# Access Compliance Report

## Public Rights-of-Way

### (Curb Ramps)

Intersection ID: 52926	Main Street: WALTHAM_LN	Cross Street: EMORY_OAK_DR	Location: E
ADA ID: EB48737C7B76	Ramp Type: Perp	Initial Pass/Fail: Fail	Overall Compliance: No
		Severity Score: 30

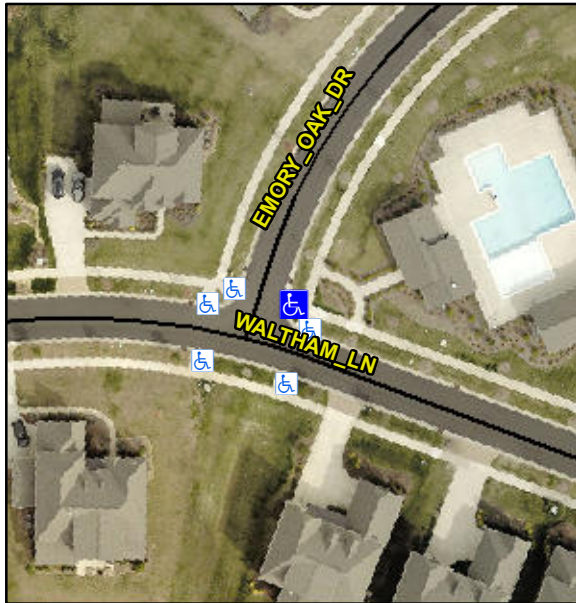
**Not Found, R304.5.1, R304.5.3**

Compliance	Description	Data	Compliance	Description	Data
N/A	Ramp Length (in)	95.5	Yes	Ramp Slope (%)	5.7
No	Ramp Width (in)	34.0	No	Ramp XSlope (%)	6.2
N/A	Flare Type LT	N/A	N/A	Flare Type RT	N/A
N/A	Flare Slope LT (%)	N/A	N/A	Flare Slope RT (%)	N/A
N/A	Flare Traversable LT?	N/A	N/A	Flare Traversable RT?	N/A
N/A	Landing Length (in)	N/A	N/A	DWS Provided?	N/A
N/A	Landing Width (in)	N/A	N/A	DWS Contrast?	N/A
N/A	Landing Slope (%)	N/A	N/A	DWS Length (in)	N/A
N/A	Landing X Slope (%)	N/A	N/A	DWS Full Width?	N/A
N/A	Landing Curb? (Y/N)	N/A	N/A	DWS Offset (in)	N/A
N/A	Shared Landing?	N/A			
N/A	Gutter Ponding?	N/A	N/A	Gutter Slope (%)	N/A
N/A	Gutter Lip Ht (in)	N/A	N/A	Gutter X Slope (%)	N/A
N/A	Painted X Walk1?	No	N/A	Painted X Walk2?	N/A
	X Walk 1 Direction	To NW		X Walk 2 Direction	N/A
N/A	X Walk 1 Width (in)	N/A	N/A	X Walk 2 Width (in)	N/A
	X Walk 1 Slope (%)	3.9		X Walk 2 Slope (%)	N/A
	X Walk 1 X Slope (%)	2.6		X Walk 2 X Slope (%)	N/A

**Remove & Replace Entire Ramp.**
